**Planning Commission Special Meeting
December 21, 2022 7:00PM
City Hall
102 Butler Street, Saugatuck, MI**

MEMORANDUM

Memo Date:	December 20, 2022	Meeting Date:	December 21, 2022
Request:	Site Plan Review	Applicant:	JPD Construction
Address:	383 Dunegrass Cir.	Project Name:	Dunegrass Residence
Parcel:	57-077-019-00	Plan Date:	May 20, 2022
Acreage:	.43	Zoning District:	PUD/CRC
Complete:	Yes	Recommendation:	See page 8
Staff:	Ryan Cummins	Consultant:	David M. Jirousek, AICP

Figure 1 - 2015 PUD Plan Focus Area

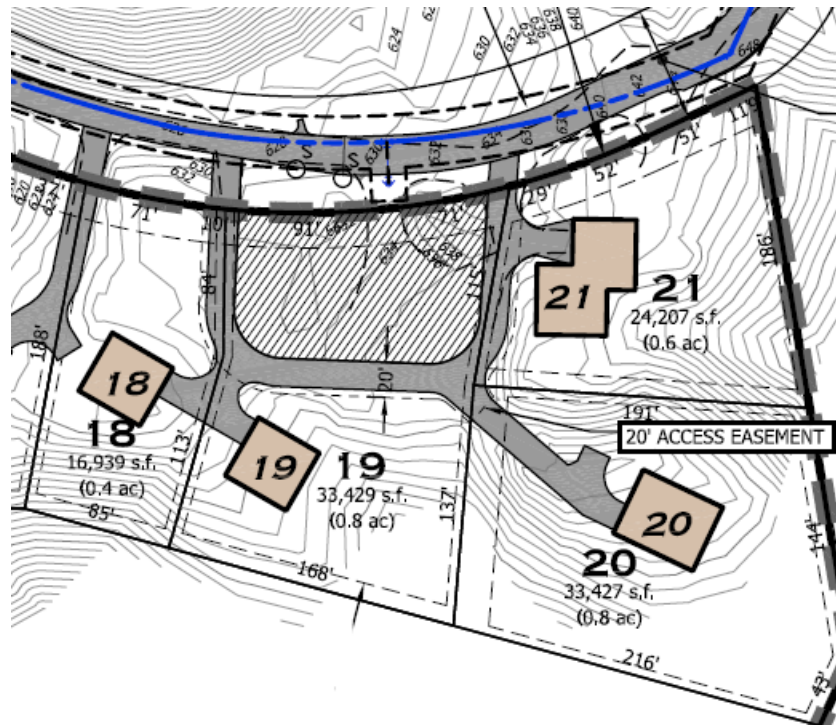
The PUD plan indicates that setback modifications were approved as part of the overall PUD process. The proposed building envelope and footprint that are shown on the site plan comply with the setbacks noted on the PUD plan (20' front, 5' side, and 10' rear).

Comment: Existing vegetation outside of the limits of disturbance will provide visual screening from the road and units to the east. There will be no screening of the west side of the dwelling from unit 18. However, screening was not intended between units 18-19 based on the shared driveway shown on the PUD plan (see plan on page 2).

Comment: The U-shaped drive from Dunegrass Circle Drive was approved in concept as part of the 2015 PUD plan. This driveway is intended to provide access to units 18-21 (see plan on page 2). As stated earlier, sidewalks or pathways are not required along the unit frontage.
